1981 Corvette: Service Bulletin: Whistle or Whine in Reverse or Lo 1 at Idle - THM 350C (MX3)

Model and Year: 1981 Corvette with THM 350C (MX3)

Bulletin No: 81-T-20

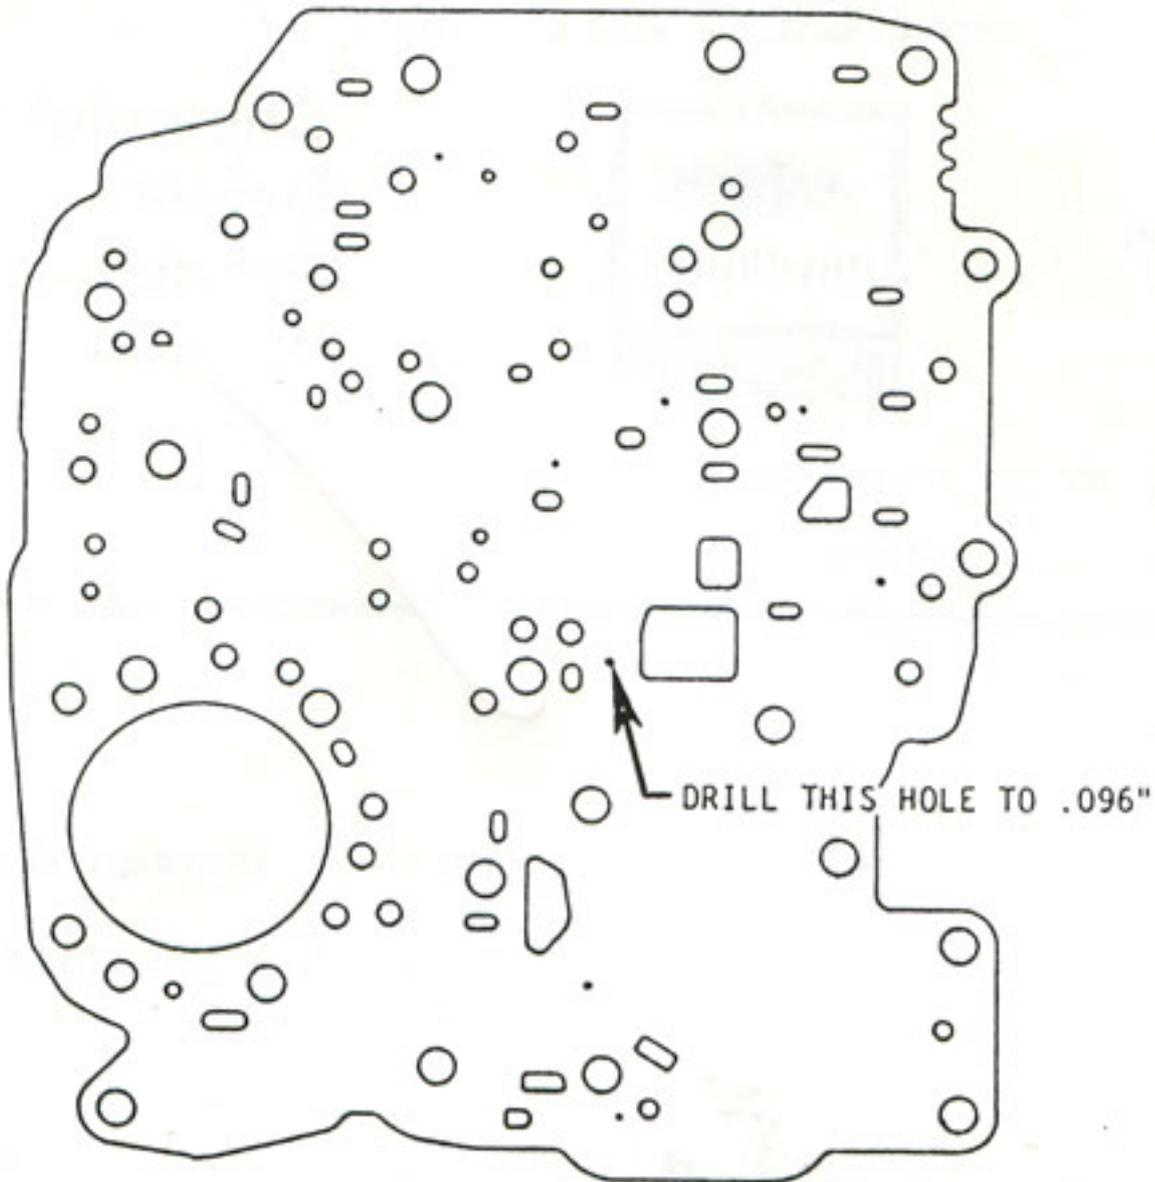
Some 350C transmissions in 1981 Corvettes and Camaros may emit a whistle or whine in Reverse or Lo1 at base idle. This is caused by the valve body spacer plate hole shown in the illustration.

To correct noise, enlarge the hole using a No. 41 drill (.096) and remove any burrs formed on either side of the plate.
